AGENDA

PLANNING & ZONING BOARD THURSDAY, JANUARY 5, 2023 6:00 PM

On behalf of the City of Reynoldsburg, EMH&T conducted a preliminary engineering review of the private development plan for the project located at 6523-6525 East Main Street. The following summarizes our findings and recommendations with respect to this development.

EAST ELEVATION

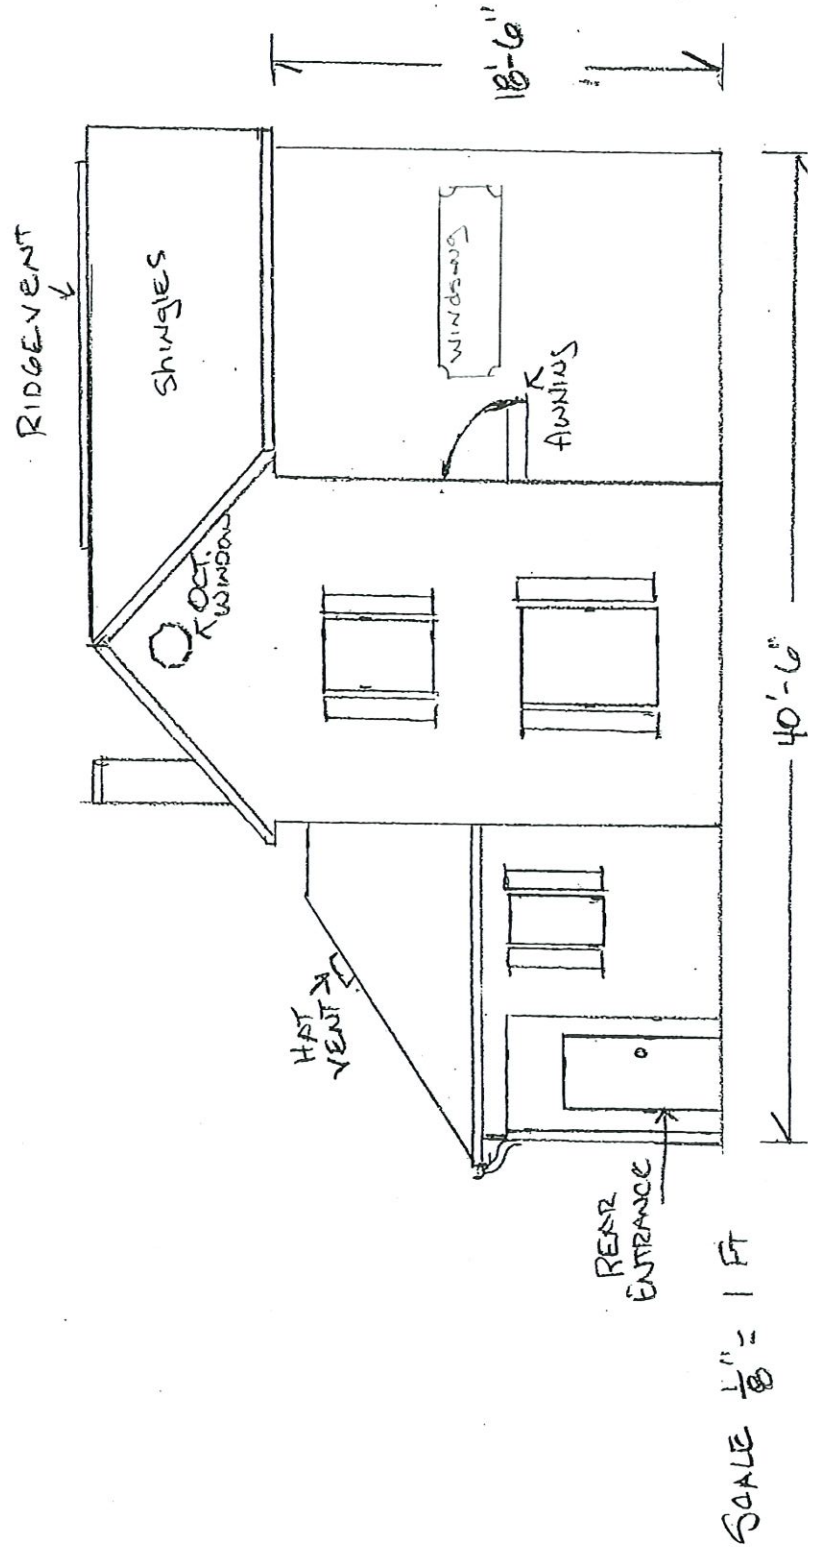
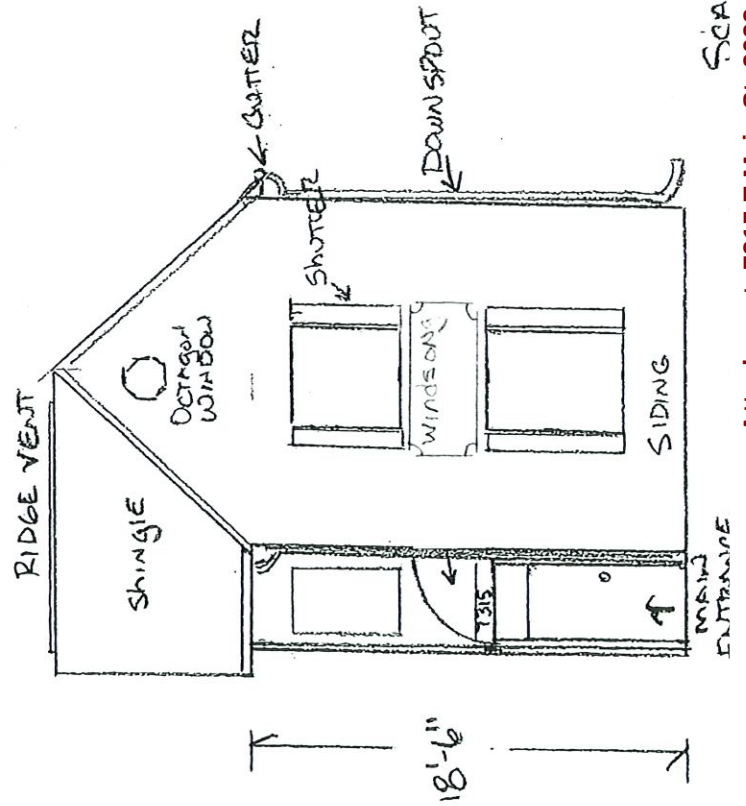
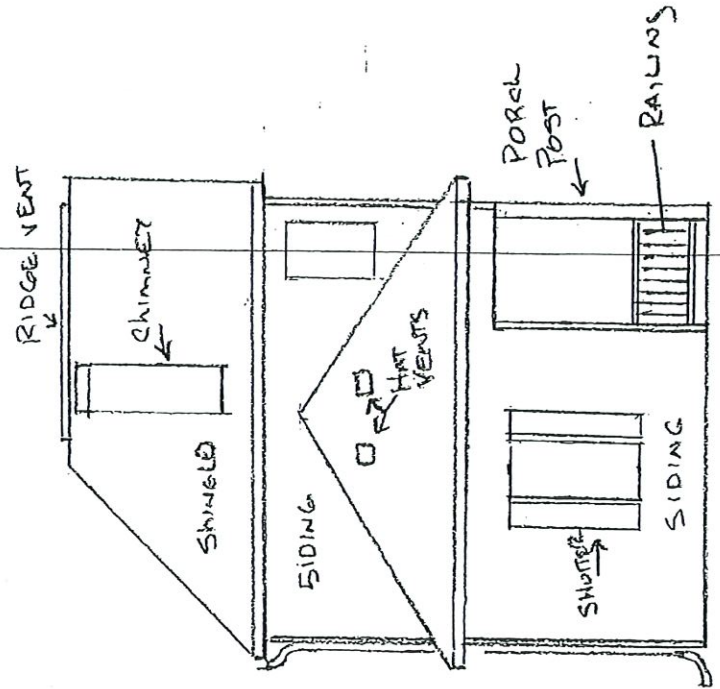
- a.** Approve the Certificate of Appropriateness with the following conditions:
 - i.** Prior to issuing a sign permit, verify that the proposed signs do not extend more than the required 12 inched from the wall and that the existing ground sign is removed.

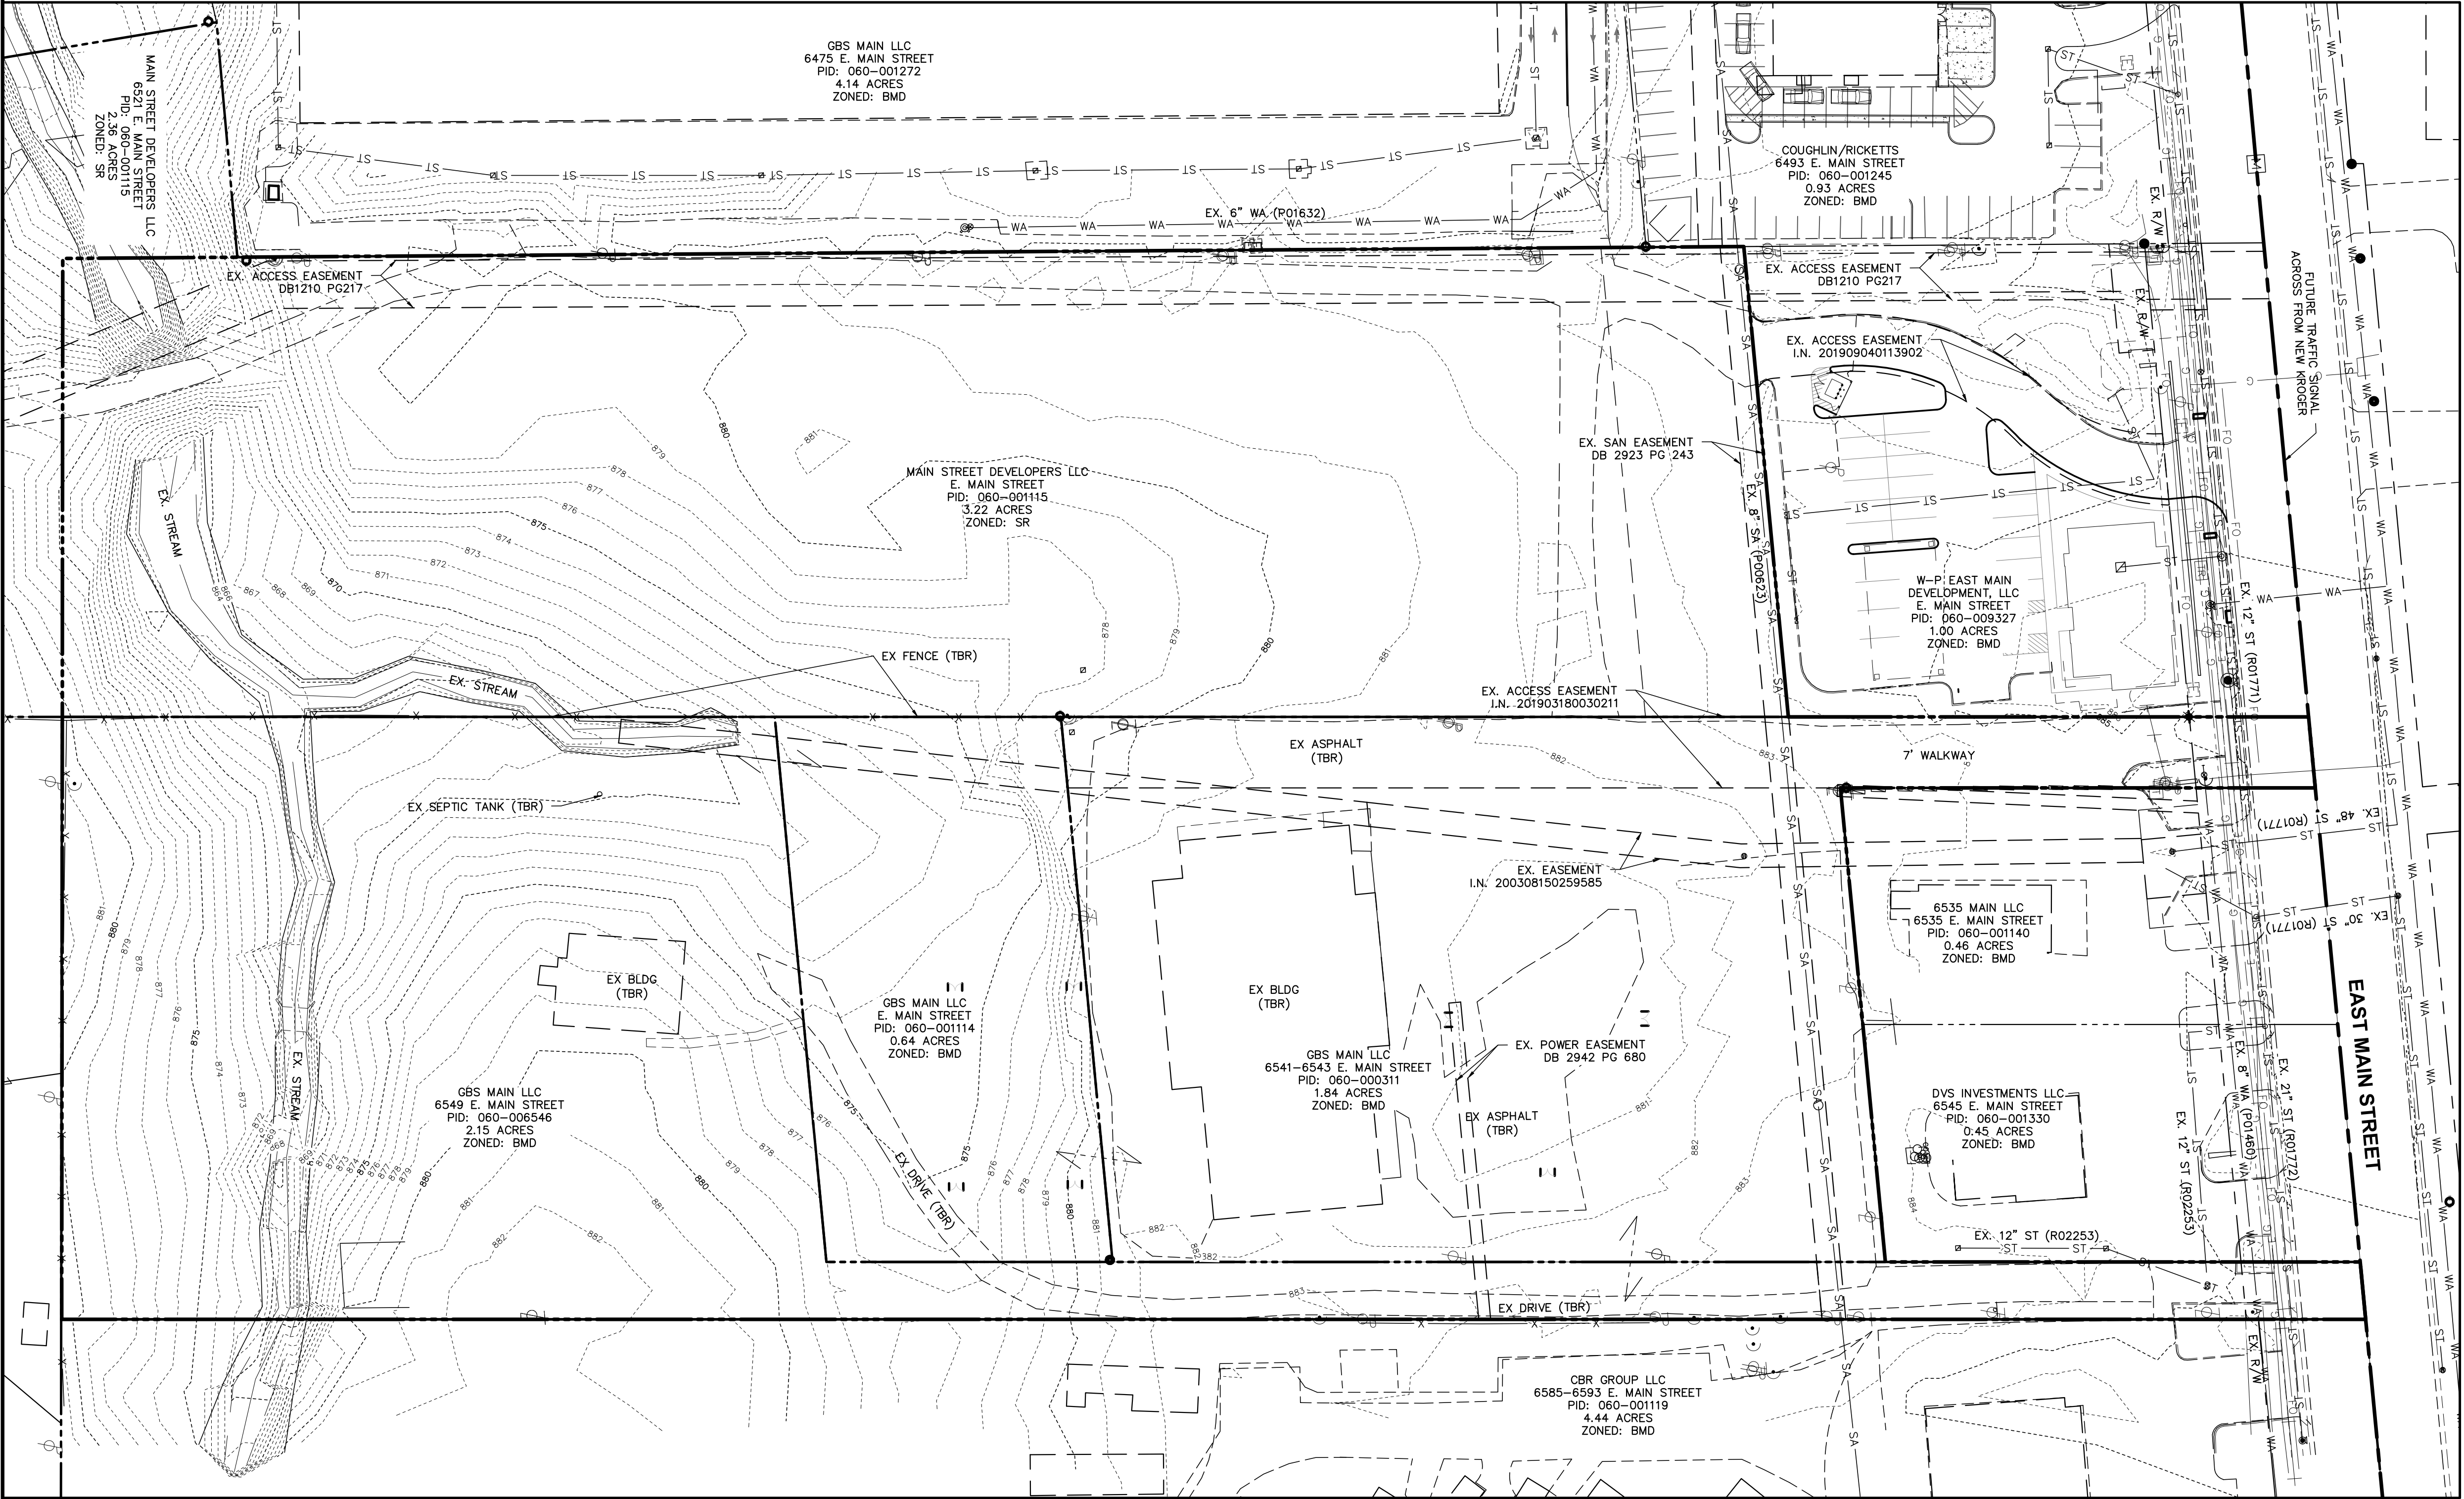
2. On the PGU plan, please specify a minimum of two of the four legs of the 4-way intersection as being a stopped condition.
3. There is an existing access easement located along the western property line which appears to provide access to a home to the south. Please confirm that this resident will no longer need this easement as it does not appear accommodations have been made to provide them access to the proposed site.

5. The central walkway from East Main Street into the site is noted. However, please revise the walkway width to be a minimum of 8-feet. The path should be constructed per Reynoldsburg's Standard Drawing R-20.

7. We understand the refuse will be picked up by a private company, but we recommend the dumpster area between buildings F & H be rotated to provide easier access for refuse trucks. As shown, the trucks would need to make 90 degree turns.

8. Sidewalk widths are not shown on the site plan. The City's minimum width for sidewalk is 5 feet, but the 4 foot width would be acceptable, if adequate width is provided for ADA access taking into account vehicle overhangs adjacent to park. Any entrance walks from the public right-of-way must be minimum 5 feet wide.

9. Please show setbacks on the site plan.
10. A lot combination will be required to prevent potential issues with setbacks.

14. Hydrants must be within 300 feet of all structures. Please verify with the fire department if the configuration shown is acceptable.
15. A sanitary sewer extension plan will be required with the PGU along with supporting calculations (see comment 12). The plan must be reviewed and approved by City of Columbus in addition to City of Reynoldsburg.

16. The sewer must be placed in a minimum 20' wide easement.
17. Site light locations, photometric analysis and cut sheet information for the poles and lights are to be submitted for review.

18. The site plan shows an easement running north to south that apparently contains a storm sewer which conveys stormwater from East Main Street and outlets to an existing stream onsite. Please show this storm sewer and any pertinent details on future submissions. We assume this will continue to be maintained through the site, please confirm.
